INTERNATIONAL STANDARD ISO 15072:1999 TECHNICAL CORRIGENDUM 1

Hexagon bolts with flange with metric fine pitch thread — Small series — Product grade A

TECHNICAL CORRIGENDUM 1

Page 3, Figure 2

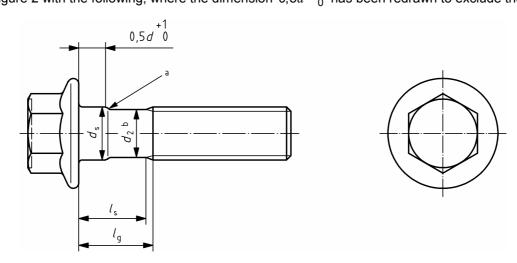
Replace Figure 2 with the following, where the dimension $0.5d^{-1}$ has been redrawn to exclude the extrusion.
